# Hi-Fi Products Service Bulletin

**Model:** HCD-C33, C55

**No.** 446

**Subject:** CD Mechanism Binding

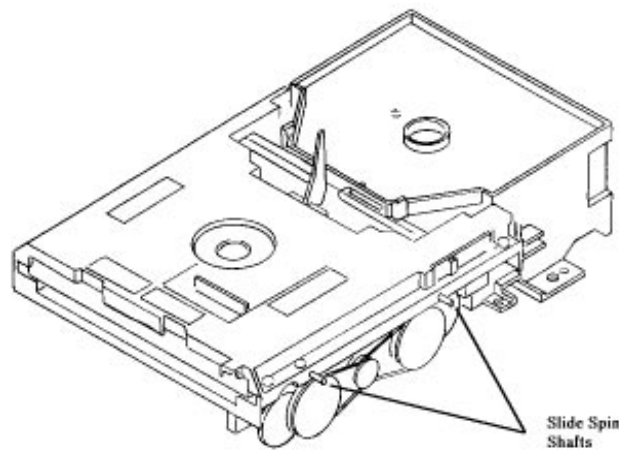
1.) On some units, rough edges have been found on the vertical cut grooves of the sub chassis assy ref. #251.

The rough edges within the vertical grooves cause the slide spin shaft (see insert) to bind. This stops the elevators Up/Down motion.

In both examples the chassis assy, sub should be replaced. The part number for the chassis assembly is X-4944-558-1. The chassis replacement should take no longer than one hour.

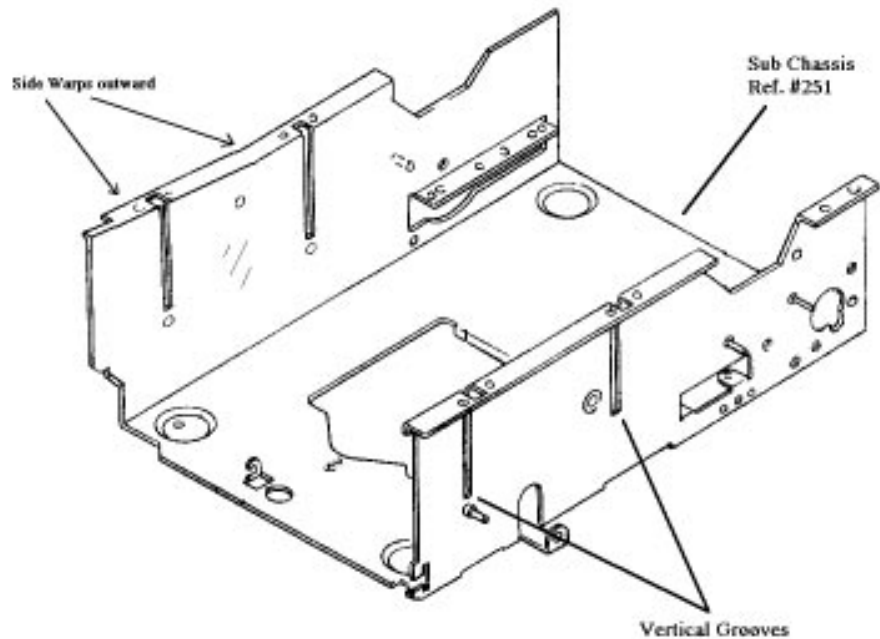
2.) In another instance, the sub chassis assy (ref.#251) can warp causing the vertical grooves to misalign. The combination of a warped chassis and misaligned grooves will cause the elevator assembly to jam.
